NOTICE OF DECISION
601 E Dartmouth Street – Shop with Accessory Dwelling Unit
Design Review – DR122-0003

Re: DR122-0003 – 601 E Dartmouth Street – Detached Shop with ADU – Notice of Decision

FILE NO: DR122-0003

REQUEST: Approval of a detached shop with an above ADU

Site Plan

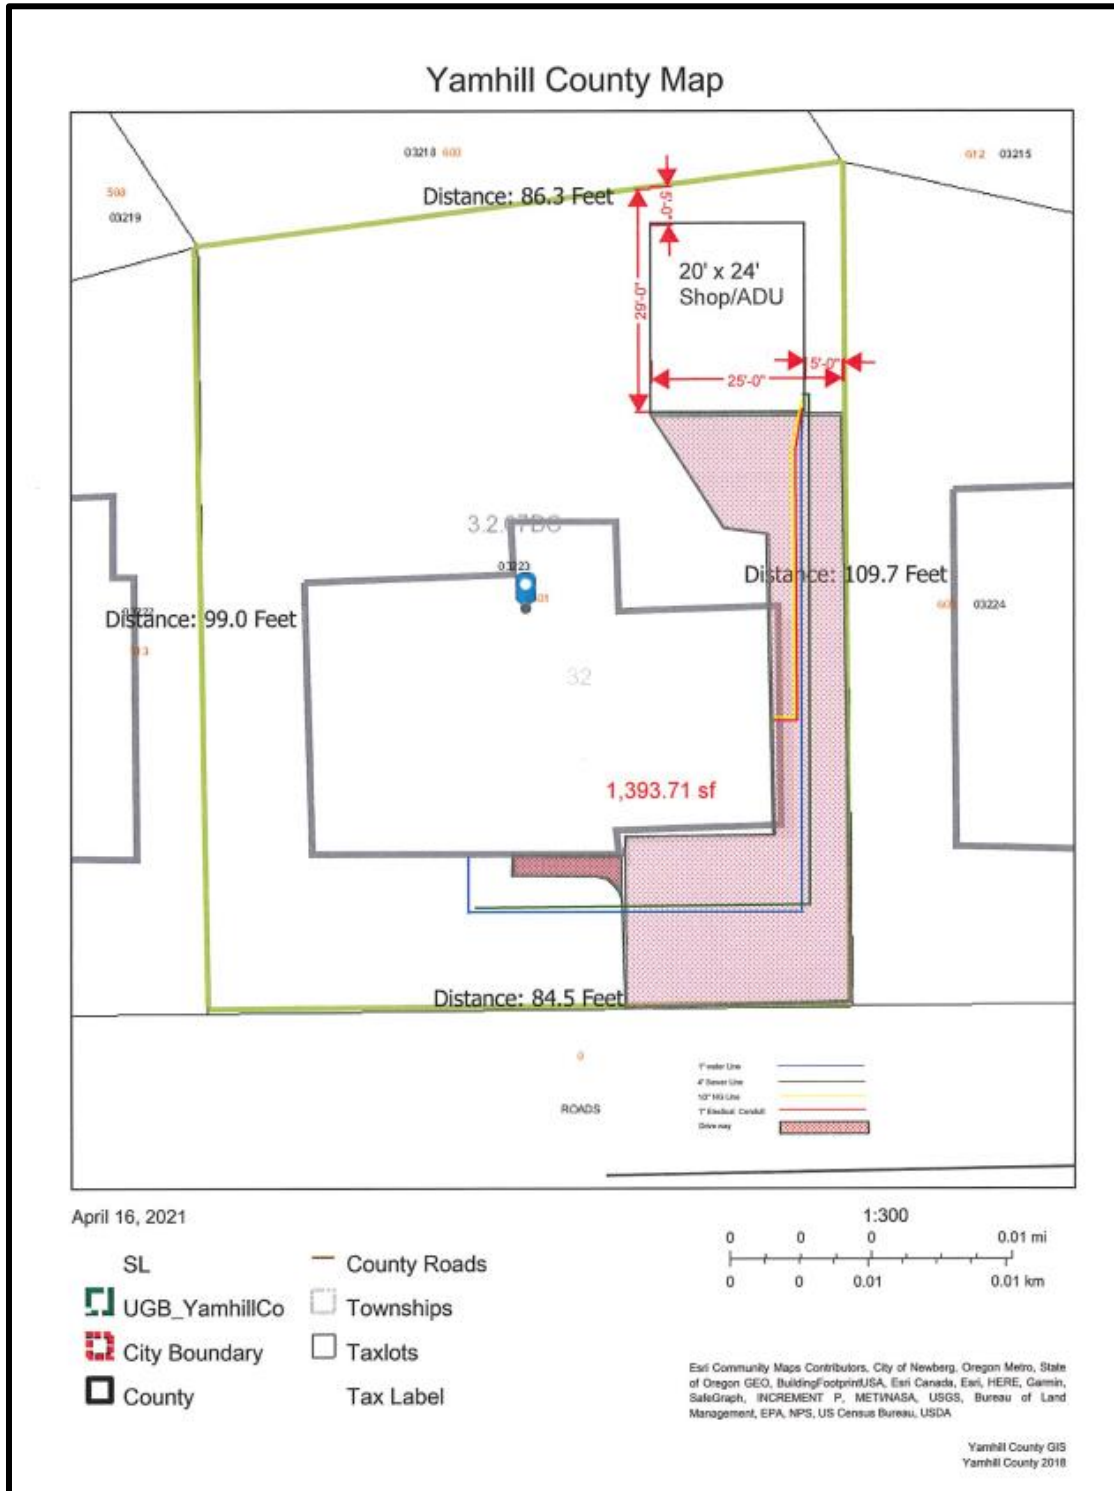
Finding: The submitted plans do not clearly show the existing sidewalk with planter strip along the project frontage. Because the condition of the existing sidewalks is uncertain, the applicant will be responsible for replacement of any sidewalk panels that are not in good condition or do not meet current ADA standards along the project frontage. Determination of any sidewalk panels to be replaced will be part of the permit plan review process.

Finding: According to the applicant's site plan, the proposed ADU will be set back at least 5 feet from the east property line. Staff was unable to accurately determine what the true setback from the rear property line will be. It appears that at the closest point the proposed shop with ADU is just under 5 feet from the property line. All interior setbacks must be 5 feet from adjacent property lines. Per NMC 15.410.070(C)(1), eaves from the building may project into the interior setback by up to two feet and be no closer than three feet from the property line. A site plan clearly showing five feet interior setbacks being maintained must be submitted with the building permit application.

Finding: The applicant's submitted narrative and preliminary plans are unclear if construction of the proposed ADU will create more than 500 square feet of impervious area. The submitted plans indicate a connection to an existing storm line for the primary residence. Because construction level plans have not been submitted, determination of any stormwater management requirements will occur as part of the building permit process. If 500 square feet or more of net new impervious area is created, the applicant will be required to meet the City's standards for stormwater management.

1. The applicant will be responsible for replacement of any sidewalk panels that are not in good condition or do not meet current ADA standards along the project frontage. Determination of any sidewalk panels to be replaced will be part of the permit plan review process.

2. A site plan clearly showing five feet interior setbacks being maintained must be submitted with the building permit application.
3. Review of the water connection for the accessory dwelling unit will occur as part of the building permit process.
